Subject: Duke Energy Carolinas, LLC  
Oconee Nuclear Station, Units 1, 2, and 3  
Docket Nos. 50-269, -270, -287  
Emergency Plan, Volume A, Revision 2012-04

SUBJECT: Oconee Nuclear Site Emergency Plan  
Volume A, Revision 2012-04

<u>REVISION NUMBER</u>	<u>EFFECTIVE DATE</u>	<u>REASON FOR REVISIONS</u>
2012-04	12/12	Section B - This change is to incorporate the new staffing analysis for the new EP rule and editorial changes.

The following changes are to be evaluated from Oconee Nuclear Station, Emergency Plan, Section B - Site Emergency Organization:  
(Screening 1 of 2 - Conforming Changes)

**FIGURE B-4A**  
**OCONEE NUCLEAR STATION**  
**Emergency Operations Facility**

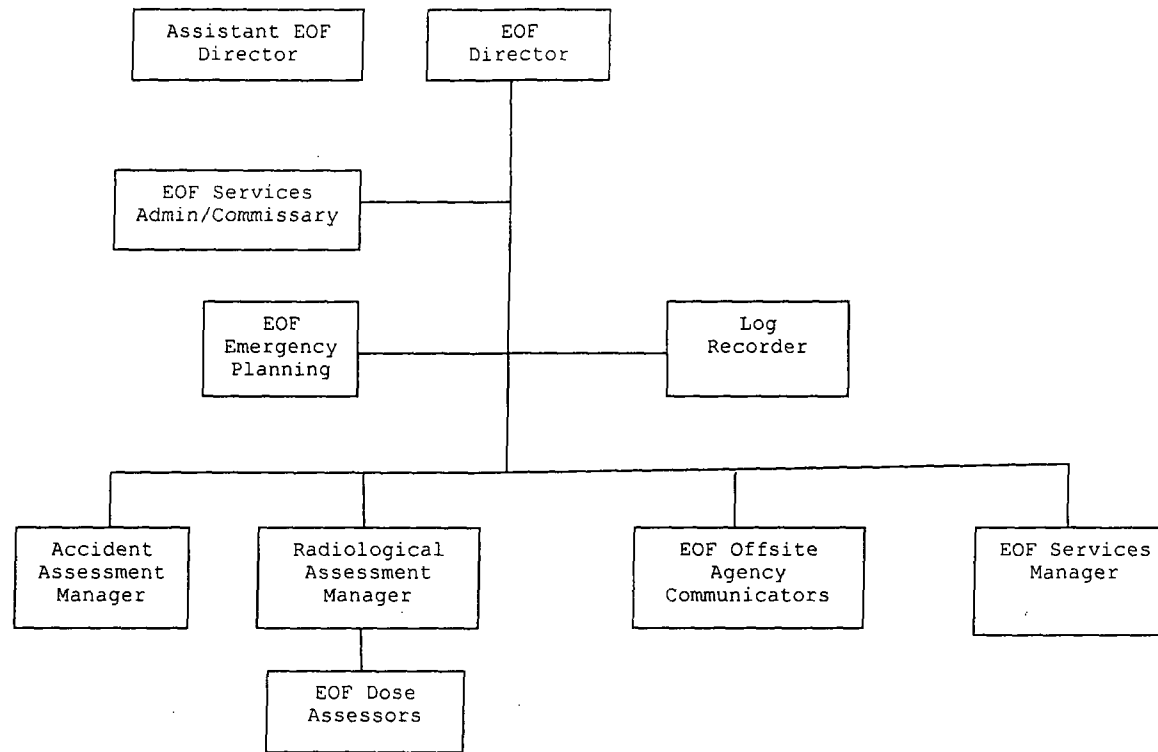
3. Figure B-1: Removed "DUKE ENERGY COMPANY" from title to maintain consistency.
4. Figure B-4A: Removed "DUKE ENERGY COMPANY" from title to maintain consistency.

**FIGURE B-4C**  
**OCONEE NUCLEAR STATION**  
**EMERGENCY OPERATIONS FACILITY**

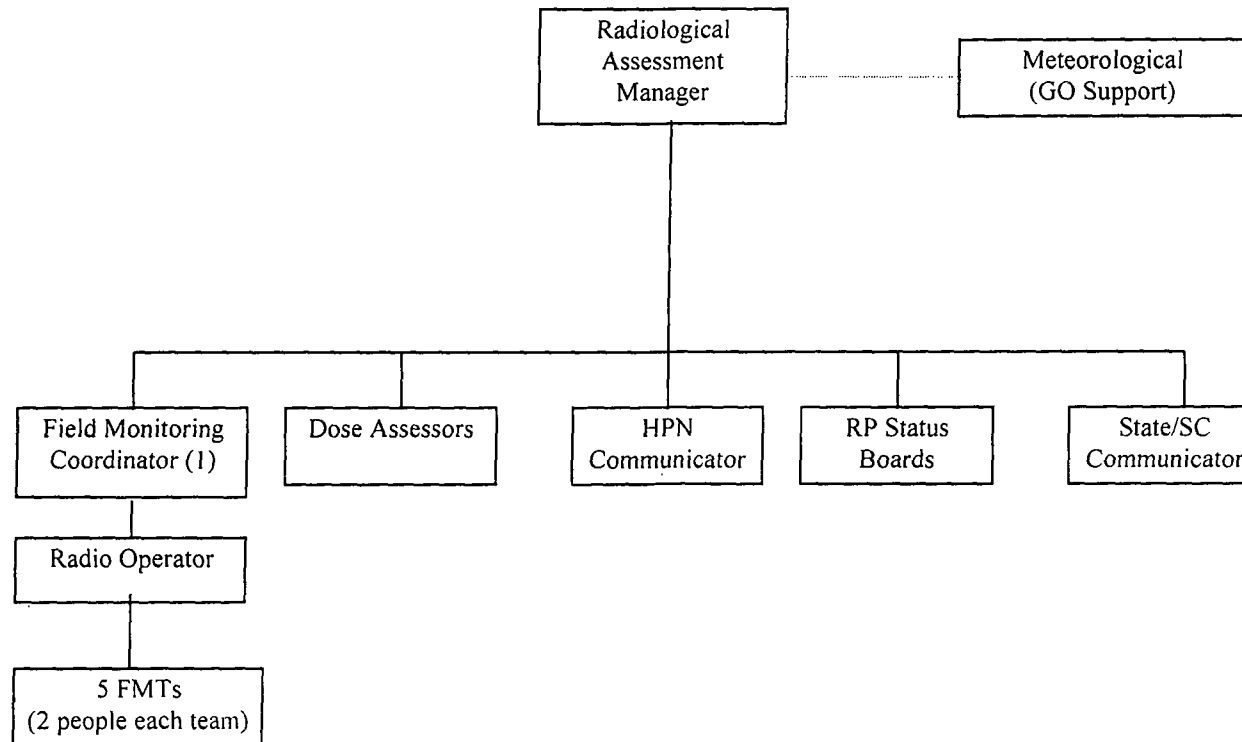
5. Figure B-4C: Removed "DUKE ENERGY COMPANY" from title to maintain consistency.
6. Figure B-5: Removed "DUKE ENERGY COMPANY" from title to maintain consistency.

**FIGURE B-9**  
**OCONEE NUCLEAR STATION**  
**MINIMUM STAFFING REQUIREMENTS**

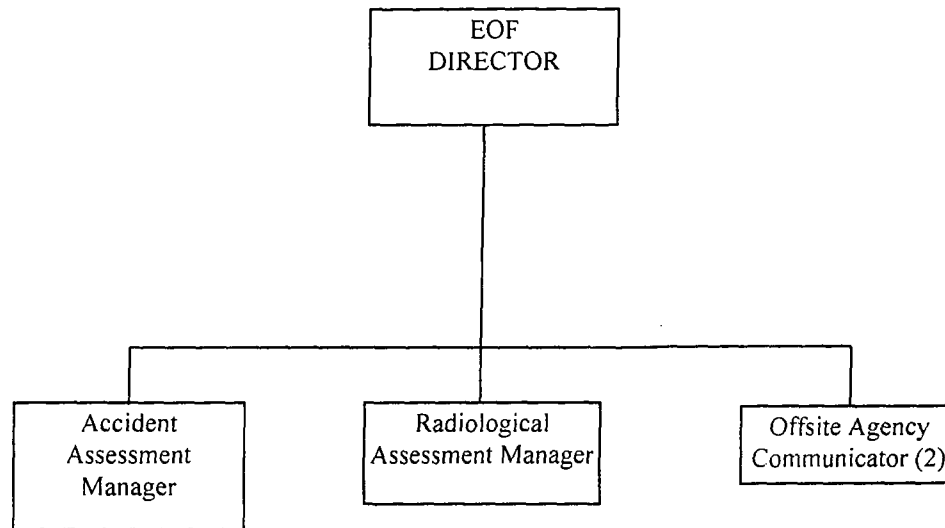
21. Figure B-9: Removed "DUKE ENERGY COMPANY" from title to maintain consistency.
22. Figure B-10: Removed "DUKE ENERGY COMPANY" from title to maintain consistency.
